UNITED STATES PATENT AND TRADEMARK OFFICE

APPLICATION NO.	FILING DATE	FIRST NAMED INVENTOR	ATTORNEY DOCKET NO.	CONFIRMATION NO.
09/769,727	01/26/2001	Robert J. Ein	035887-0106	5192

Office Action Summary

DETAILED ACTION

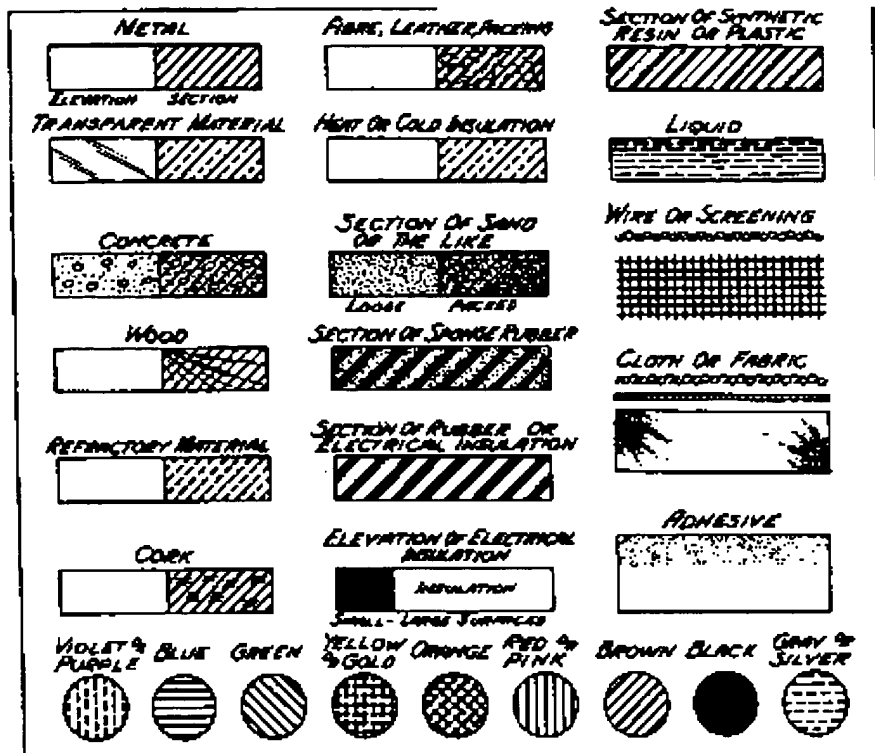
Fig. 4A-4E: Proper cross-sectional hatching is required to properly denote **insulative and metallic** materials in accordance with MPEP 608.02 (see the drawing below for proper hatching examples).
